CITY OF WINTER PARK PLANNING AND ZONING BOARD

Staff Report June 4, 2019

SPR 19-06

REQUEST OF JUSTIN AND LINDSAY VERMUTH FOR APPROVAL TO CONSTRUCT A 1,424 SQUARE FOOT TWO-STORY ADDITION TO THEIR SINGLE-FAMILY HOME LOCATED AT 725 BALMORAL ROAD ON LAKE BERRY, ZONED R-1AAA. VARIANCES ARE REQUESTED FOR THE SOUTHERN SIDE SETBACKS.

HOWELL BRANCH PROJECT SITE PLAN

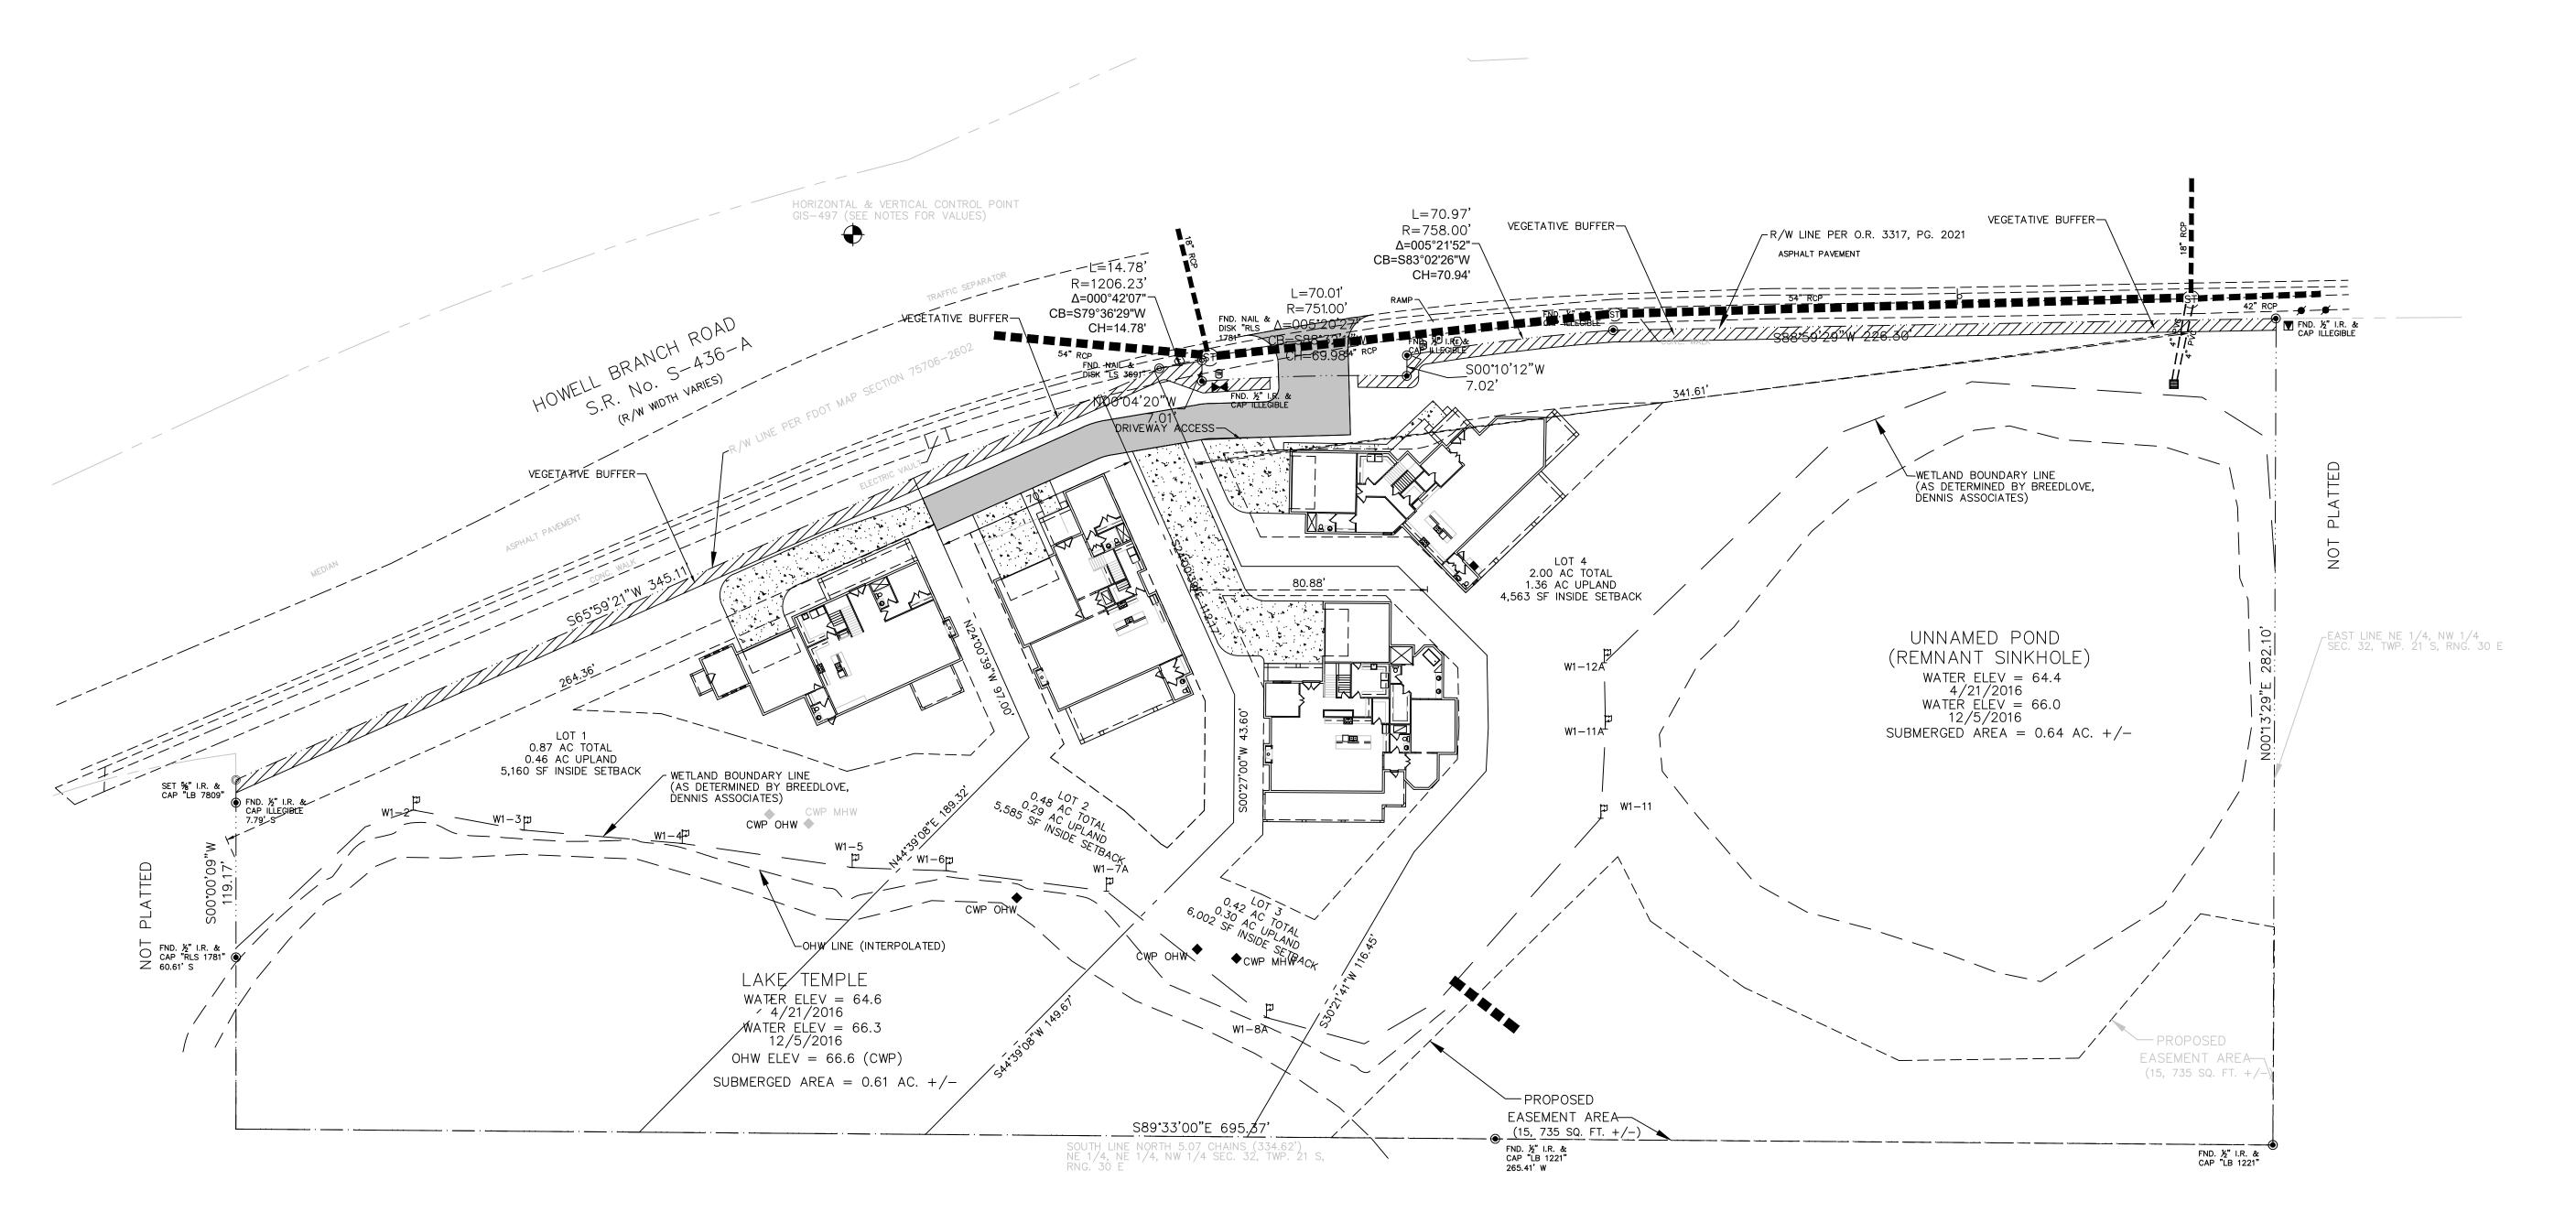
Development Plans: The applicant has provided conceptual site plan layouts of new homes to indicate that the buildable areas are sufficient for single-family homes. However, the specific plans, layout, elevations, etc. will not be developed until the lots are sold to builders. It is important to point out that while these lots are zoned R-3, the applicant is in agreement to comply with the normal single-family zoning development standards with respect to setbacks, floor area ratio, building articulation, etc.

Access to the proposed lots, into and out of this property was an issue in the initial staff reviews. Access driveways to each individual lot presented safety concerns given sight lines, speed of traffic, U-turns necessary, etc. As a result, these four lots will use a private access easement/common driveway. All traffic is to enter and exit on Howell Branch Road via the signalized intersection at Temple Trail and Howell Branch Road, onto the roadway with 30,600 cars a day. Utilizing access at the traffic light will insure safe turning movements into and out of the property. The traffic signal upgrades will be done at the applicant's expense.

Technical Advisory Committee Comments: During the review by other city departments, the site plan was revised, per the comments from the various departments to the form submitted. The Public Works Department has also asked for an easement for those sections of the sidewalk along Howell Branch Road that encroach upon this property, as well as a drainage easement over the weir or control structure between these two water bodies in case maintenance work is required. The applicant is in agreement with those requests. Other comments from Public Works related to the traffic signal upgrades have been agreed to by the applicant. Similarly, the sanitary sewer lift station necessary for this project will be designed to meet city specifications.
